ADDENDUM NO. 1

SLATER PARK DOG PARK RENOVATIONS

BID #23-037

ISSUED: April 20, 2023

Demolition Plan

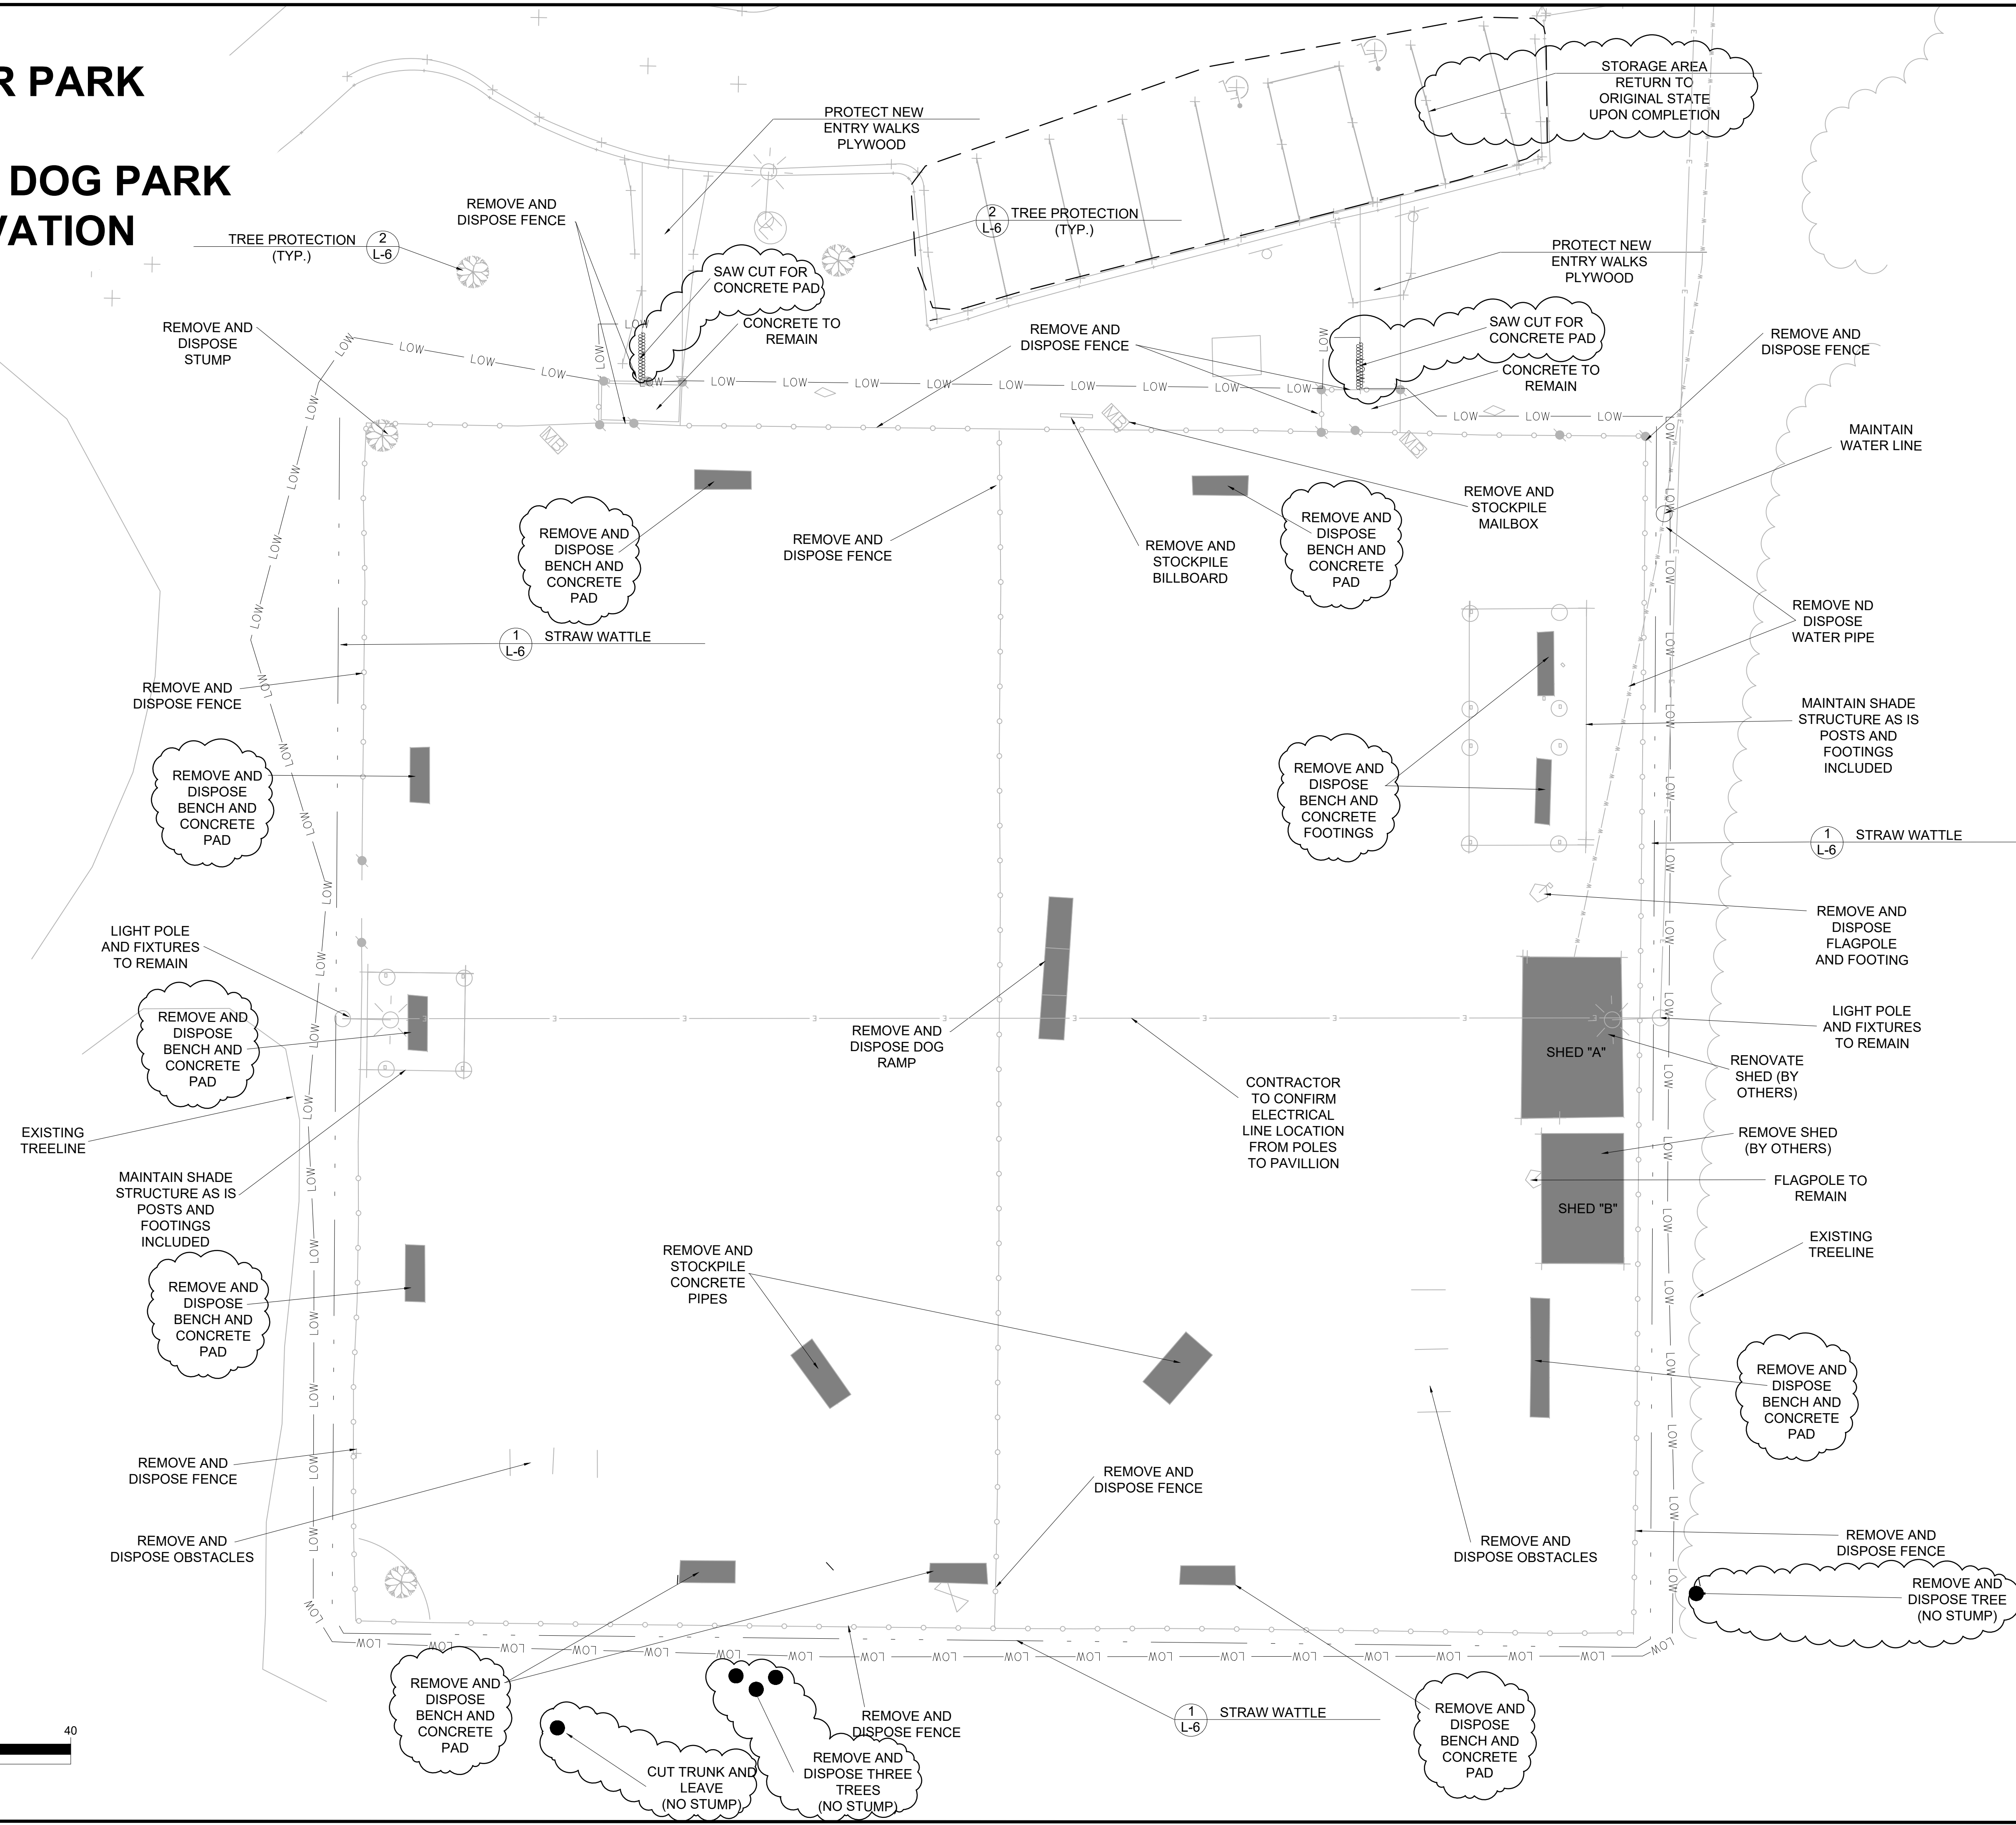
Q1: *Tree removal that was discussed at the pre-bid yesterday. Perhaps you can establish a tree removal allowance?*

A1: *There were four (4) trees located outside the fence on the east side of the site. These trees are identified on the attached plan set Sheet L-1 as remove and dispose and included on the revised bid form(attached) as Bid Item No. 4. There will be no allowance for this work.*

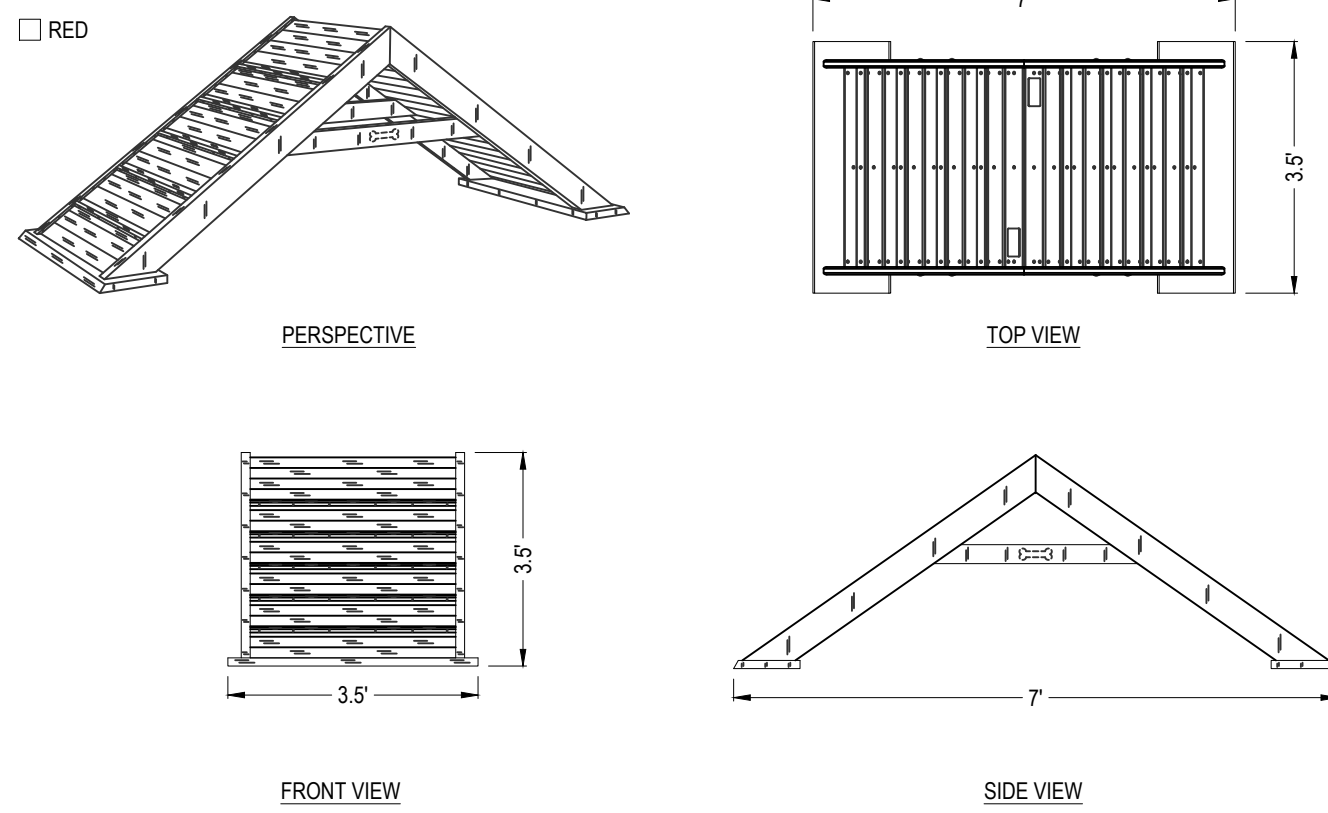
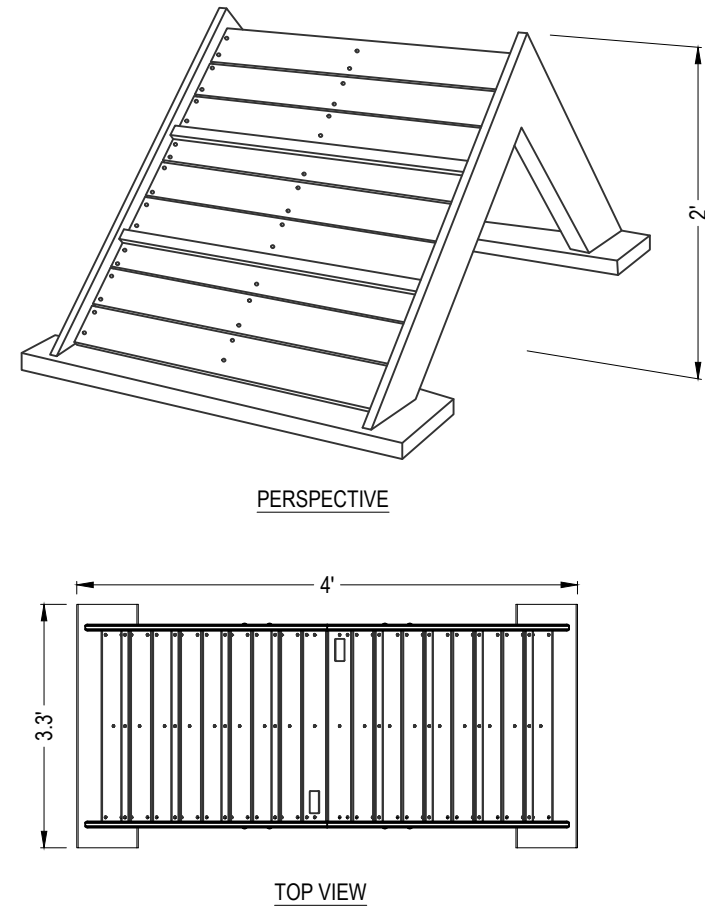
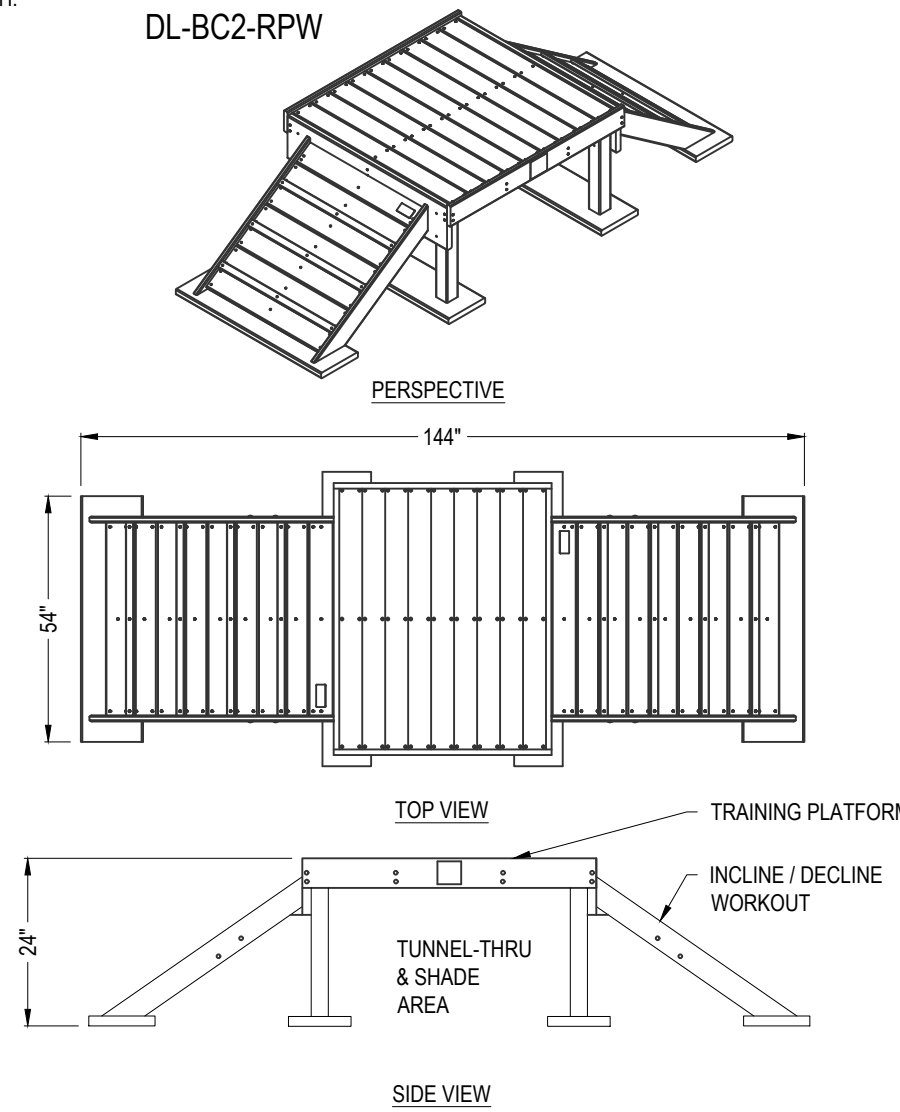
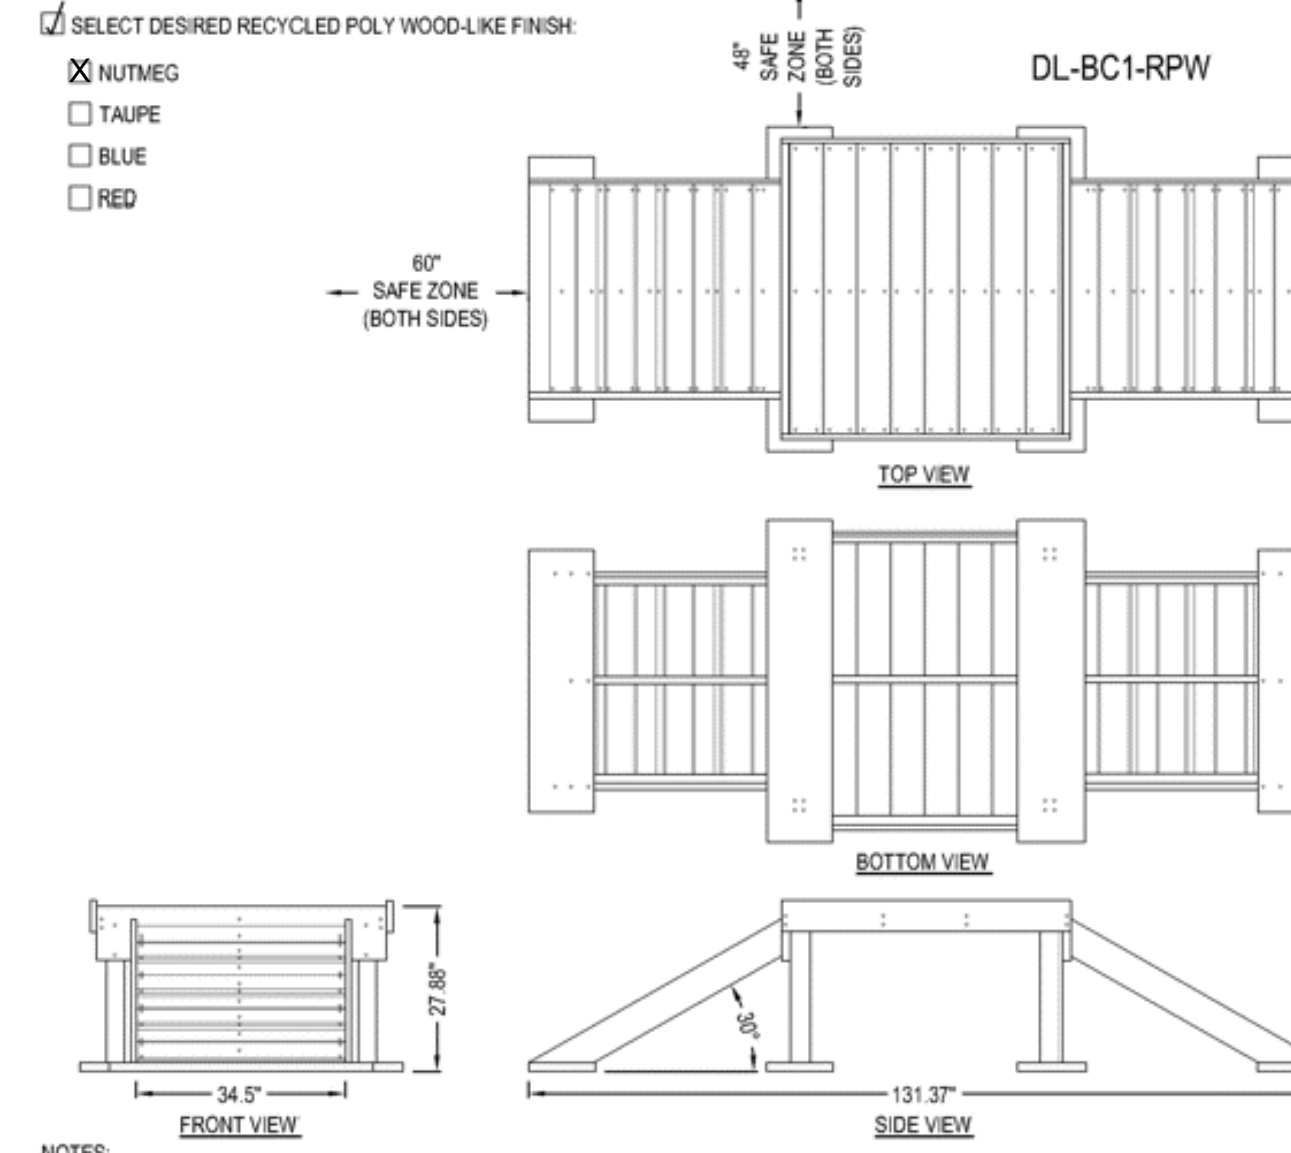
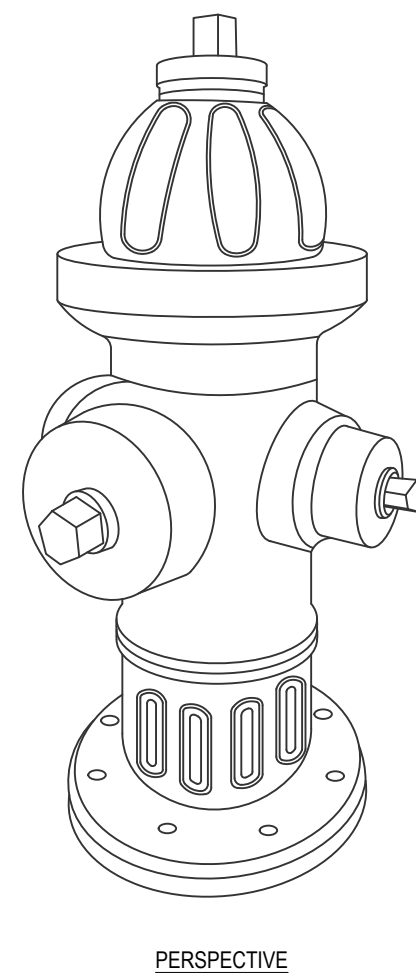
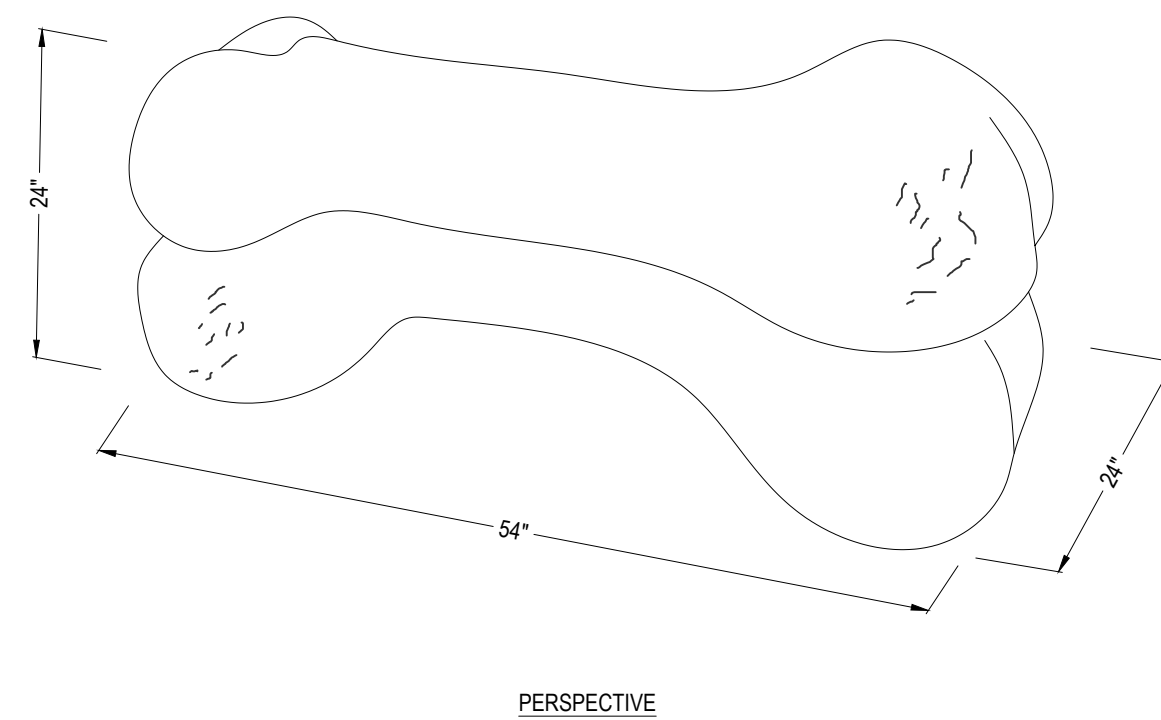
Alternate #1 shall be the ADDITION of eight dog feature units as shown as detailed on Sheet L-7. Work includes provision, assembly, and installation of:

- Large and small bridge climb (nutmeg color)
- Large and small hill climb (nutmeg color)
- Two small agility bone
- Two free standing hydrants
